**Re: Pacific Northern Gas Ltd.
Application for Approval of Letter Agreement between
Pacific Northern Gas Ltd. and Triton LNG Limited Partnership
Responses to BCUC Information Request No. 1**

**Pacific Northern Gas Ltd.
Pacific Northern Gas Ltd. and Triton LNG Limited Partnership
Letter Agreement Application**

INFORMATION REQUEST NO. 1 TO PNG

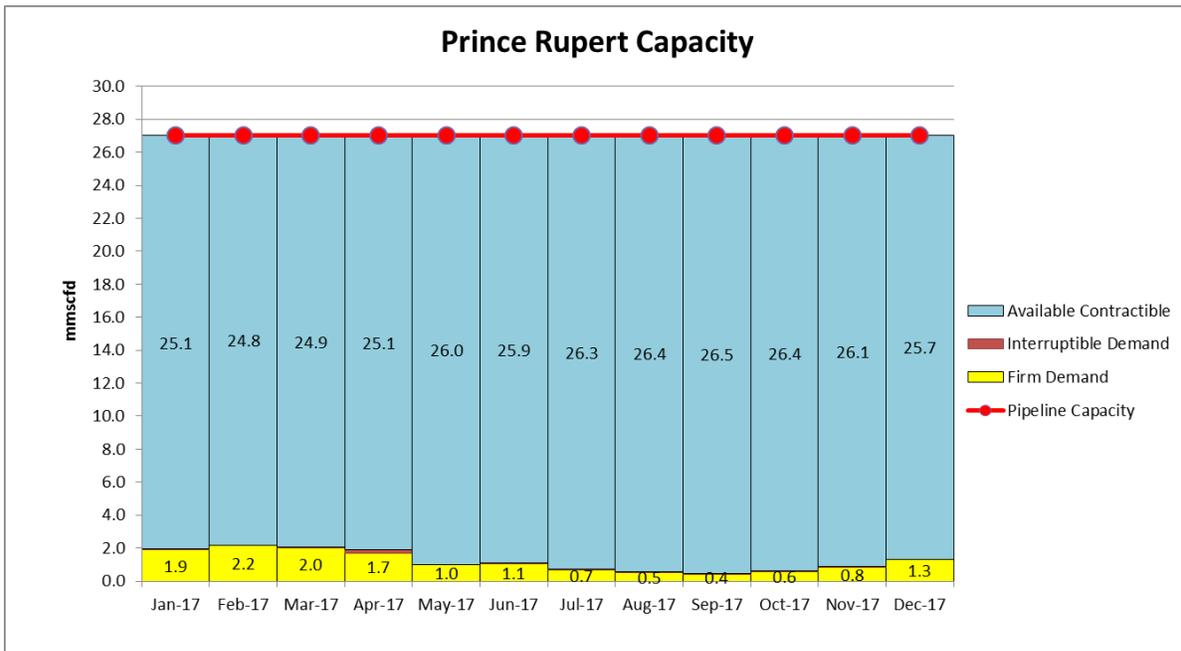
1.7 Please provide a tabular and graphical representation of the monthly capacity demands (both firm and interruptible) of existing customers, the total contractible demand available and the total pipeline capacity under design year conditions.

Response:

Please see the following table and chart for capacity to the Prince Rupert area for 2017. PNG notes that its largest industrial customer in the Prince Rupert area had low demand during this period.

Jan-17	Feb-17	Mar-17	Apr-17	May-17	Jun-17	Jul-17	Aug-17	Sep-17	Oct-17	Nov-17	Dec-17
Firm Demand	1.91	2.16	2.03	1.71	0.99	1.06	0.68	0.53	0.43	0.55	0.83	1.31
Interruptible Demand	0.03	0.03	0.03	0.21	0.02	0.02	0.02	0.05	0.05	0.05	0.06	0.01
Available Contractible	25.06	24.82	24.94	25.08	25.99	25.92	26.29	26.42	26.53	26.40	26.11	25.67
Pipeline Capacity	27.00	27.00	27.00	27.00	27.00	27.00	27.00	27.00	27.00	27.00	27.00	27.00
